ALERT SERVICE BULLETIN

TITLE: Servo-control system - Check of the connection between the upper ball bearing end and the main rotor servo-control

ASB EC155-67-30-0001

Issue 001 2024-04-18
Issue 002 2024-05-15

Figure 1

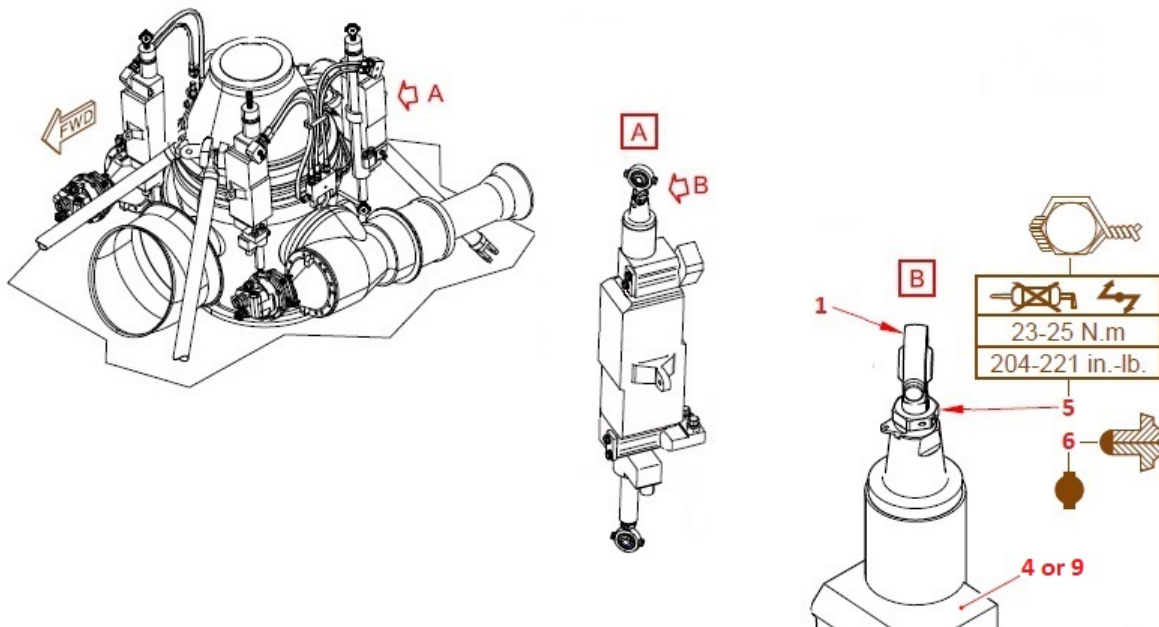
- 4.1. Only the procedure for the left rear main rotor servo-control is given. Do the same procedure for the left front main rotor servo-control and the right front main rotor servo-control, unless differently specified.
- 4.2. Do a check of the nut (5) tightening torque of the Ball bearing end 1211351P (1) of the Main rotor servo-control SC8037-1 (4) or Main rotor servo-control SC8037 (9) (Figure 1). Refer to Work Card Assembly by screws and nuts - Joining [MTC 20-02-05-404](#).

4.2.1. If you get to the minimum torque 2.3 daN.m (204 lbf.in) value before the marks align:

4.2.2. If the tightening torque value is more than or equal to 2 daN.m (177 lbf.in) and less than 2.3 daN.m (204 lbf.in) when you get to the alignment of the marks (corresponds to a loss of tightening torque less than 15% of the minimum torque value):

4.2.3. If the tightening torque value is less than 2 daN.m (177 lbf.in) when you get to the alignment of the marks (corresponds to a loss of tightening torque more than 15% of the minimum torque value):

- Torque until the marks align but do not torque to more than the max torque value given in figure 1
- Use Lock-wire CM 776 to safety the nut (5) with the nut retainer (6).
- Apply a bead of Sealing compound CM 6068 to:
 - The upper end of the Main rotor servo-control SC8037-1 (4) or Main rotor servo-control SC8037 (9)
 - The nut (5)
 - The nut retainer (6)
 - The Lock-wire CM776.
- Comply with paragraph 4.5.

- Torque the nut (5) to the nominal values given in Figure 1.
- Use Lock-wire CM 776 to safety the nut (5) with the nut retainer (6).
- Apply a bead of Sealing compound CM 6068 to:
 - The upper end of the Main rotor servo-control SC8037-1 (4) or Main rotor servo-control SC8037 (9)
 - The nut (5)
 - The nut retainer (6)
 - The Lock-wire CM776.
- Comply with paragraph 4.5.

- Comply with paragraph 4.3.

Figure 2

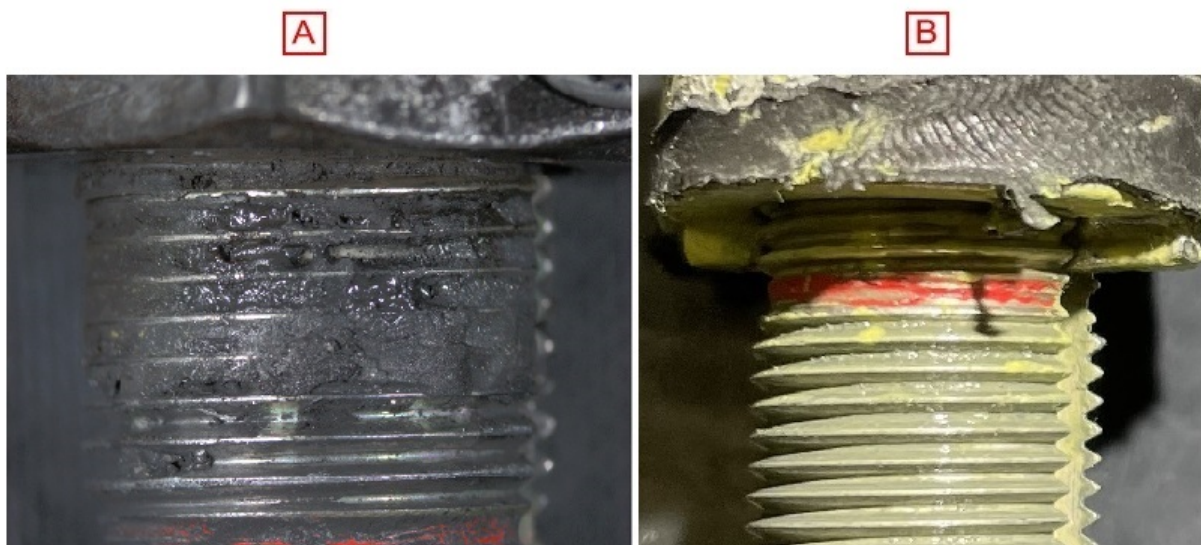
4.3.3. Do a detailed visual inspection of threads of the Ball bearing end 1211351P (1) (Figure 2).

4.3.3.1. If there is no dirt, no corrosion and no damaged threads (Figure 2, Detail B):

4.3.3.2. If there is dirt (Figure 2, Detail A), corrosion or damaged threads:

- Clean the Ball bearing end 1211351P (1) with Cleaning agent CM 208. Refer to Work Card Use of cleaning products on individual parts and on helicopters - Cleaning [MTC 20-04-01-102](#) Cleaning agent
- Keep the removed Ball bearing end 1211351P (1).

- Do photos of the threads
- Discard the Ball bearing end 1211351P (1).

Figure 3

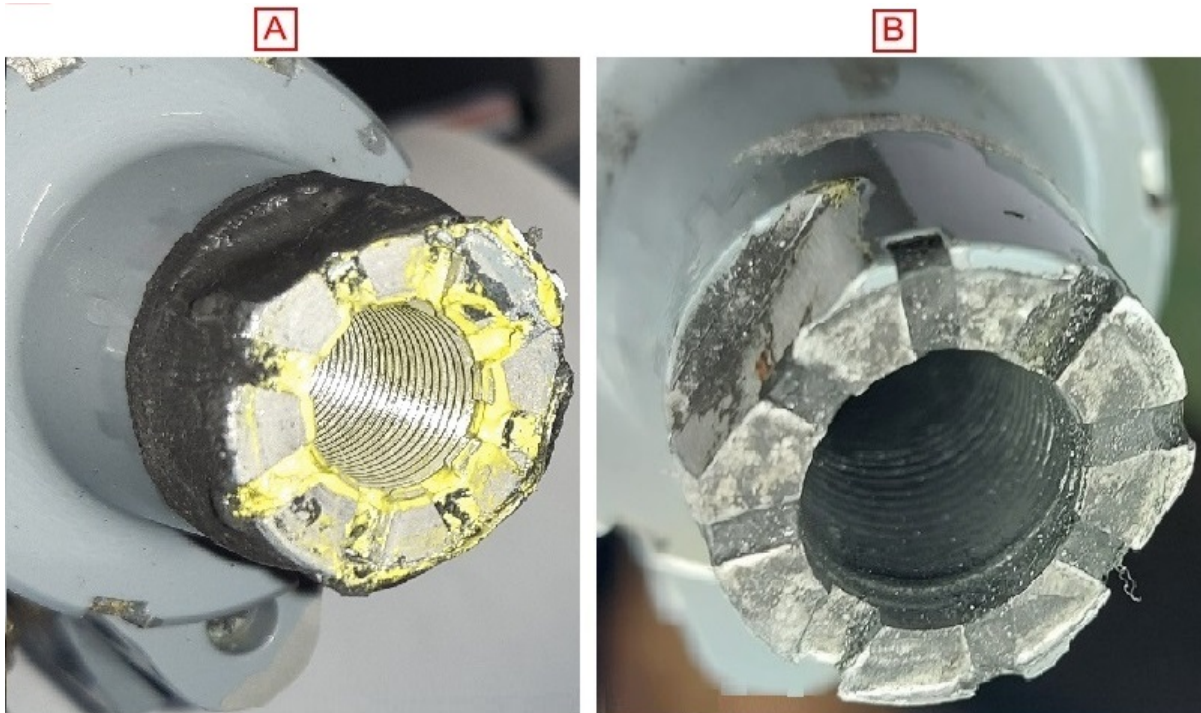
- 4.3.4. Do a detailed visual inspection of the threads on the inner surface of the upper end fitting of the Main rotor servo-control SC8037-1 (4) or Main rotor servo-control SC8037 (9) with the Flashlight (7) (not shown) and the Articulated mirror (8) (not shown):
- Do photos of the threads
 - Clean the threads on the inner surface of the upper end fitting of the Main rotor servo-control SC8037-1 (4) or Main rotor servo-control SC8037 (9) with Cleaning agent CM 208. Refer to Work Card Use of cleaning products on individual parts and on helicopters - Cleaning [MTC 20-04-01-102](#)
 - Do photos of the threads after cleaning.
- 4.3.4.1. If there is oxidation, corrosion or damaged threads (Figure 3, Detail B), comply with paragraph 4.4.
- 4.3.4.2. If there is no oxidation, no corrosion and no damaged threads (Figure 3, Detail A), comply with paragraph 4.3.5.

- 4.3.5. Turn a serviceable (new one or removed one if the threads were clean) Ball bearing end 1211351P (1) until its threads are almost fully in the upper end fitting of the Main rotor servo-control SC8037-1 (4) or Main rotor servo-control SC8037 (9):
